ADDENDUM

ADDENDUM NO.: 05

PROJECT NAME: 1819 W. Pershing Renovation (Pershing Road Center Building)

DATE OF ISSUE: 12.30.22

E-200

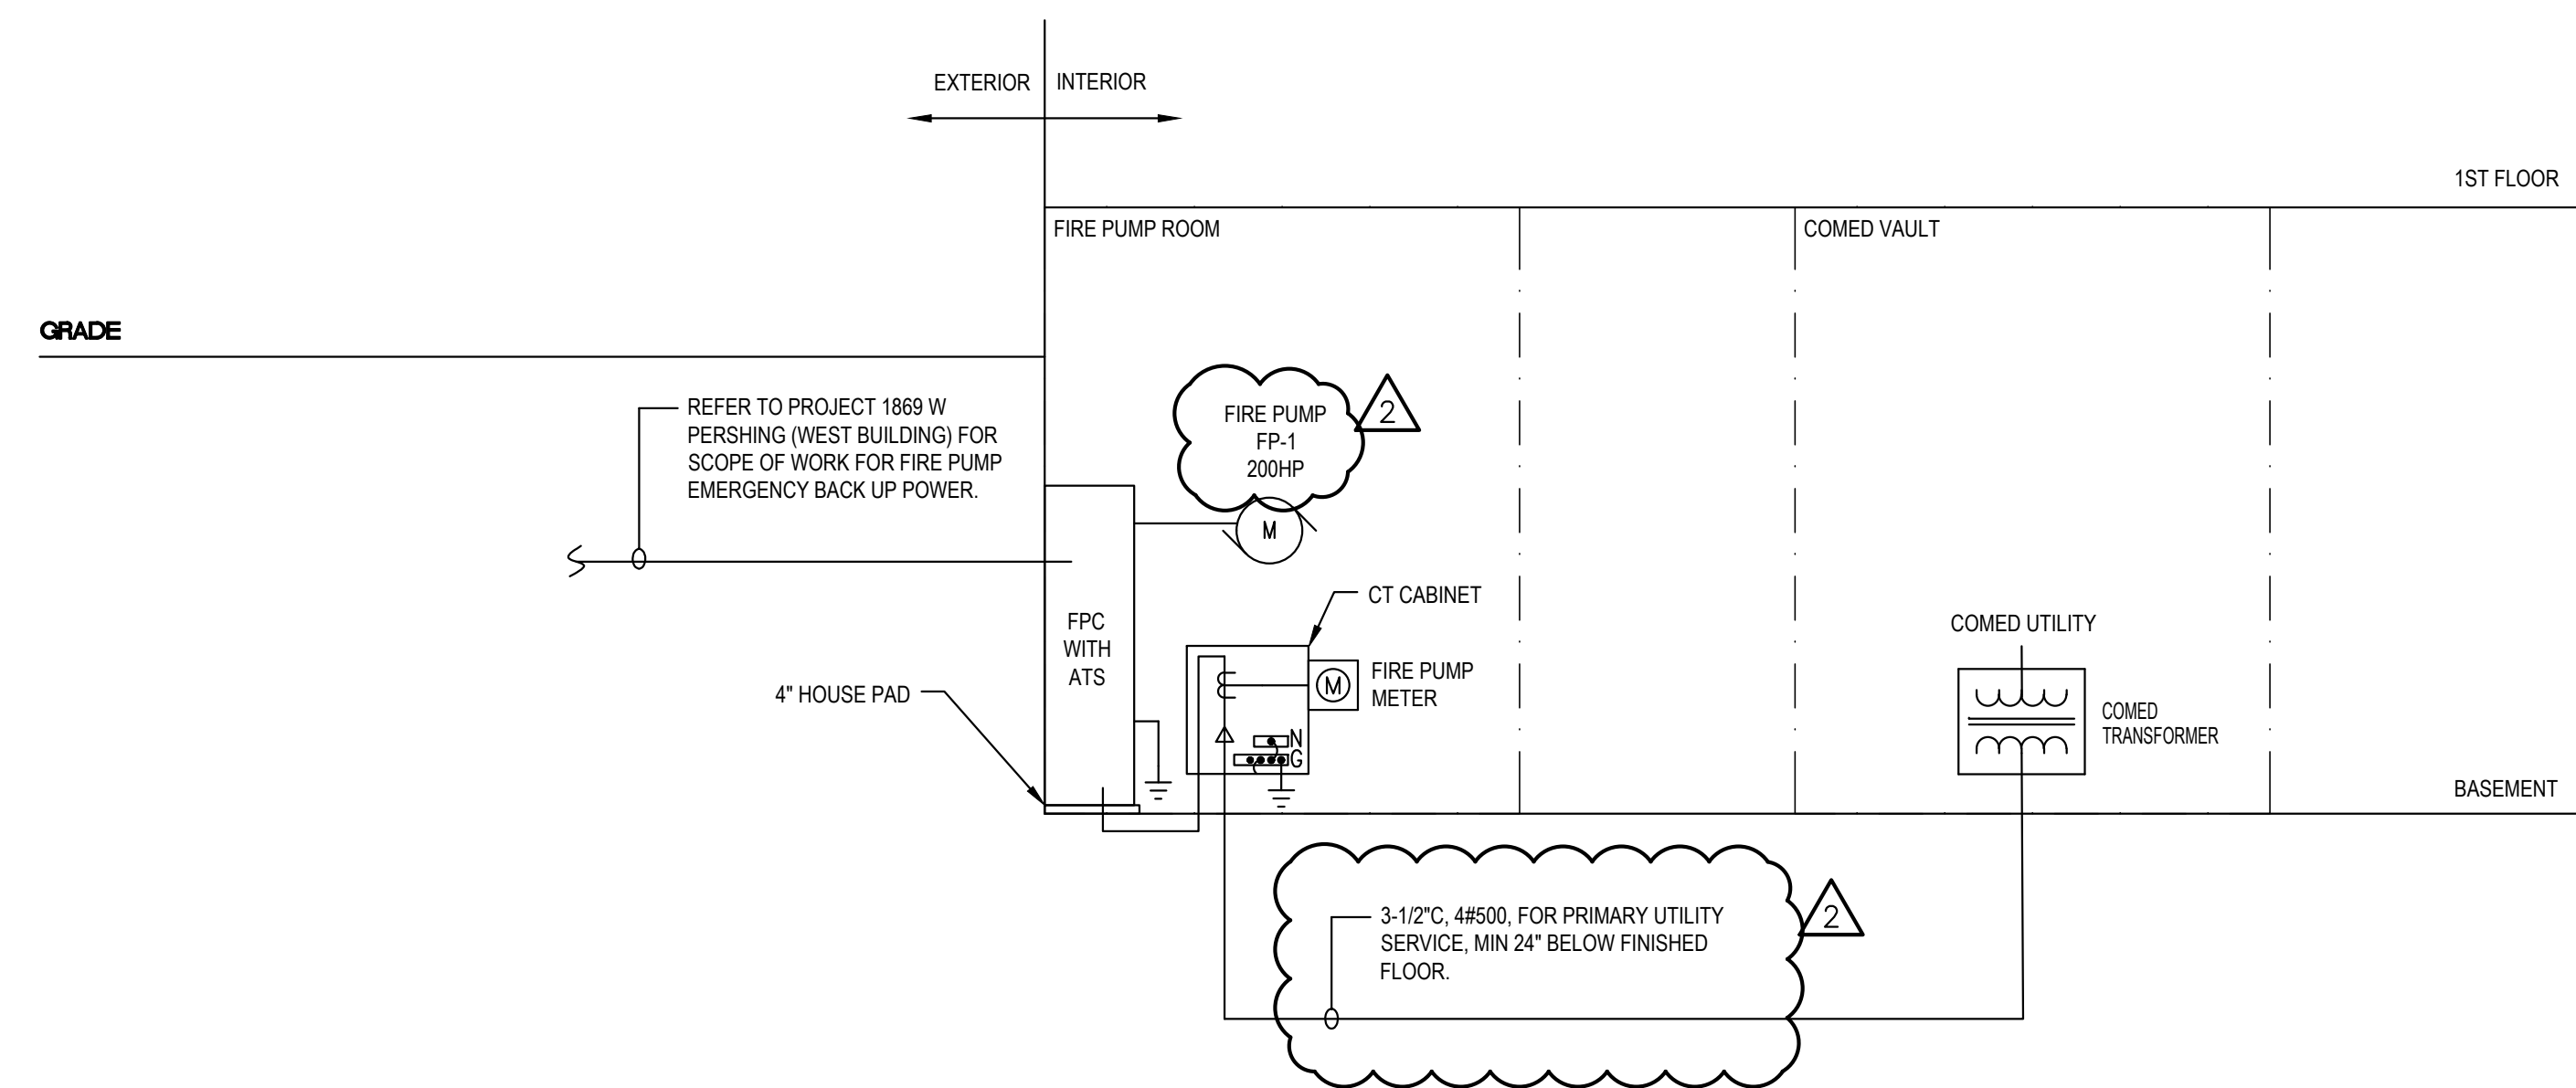
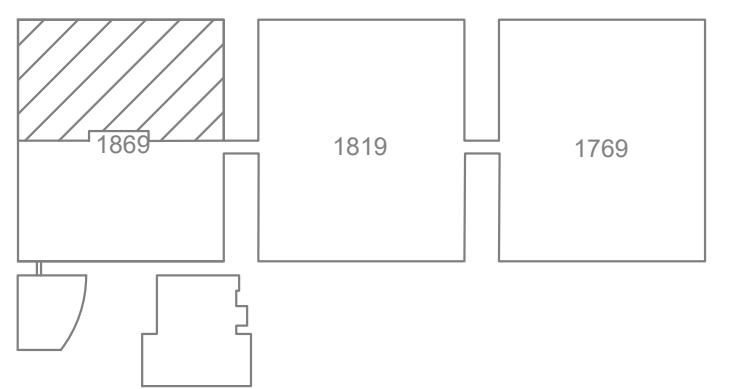
2. **(Question)** Is the installation of a new power feed to the new fire pump part of project #04026 Bid Package #1? If so, we would need to know the pipe & wire size required and where the normal and emergency power originate from.

- a) Insert new sheet – Power Connection Details for Fire Pump

- **Response:** Yes, a new power feed for the fire pump is part of the project. Bidders are advised to refer to E-200 Basement Electrical Power Plan – North- West BLDG. included in this Addendum 5 for full details related to pipe size, wire size and pipe location.
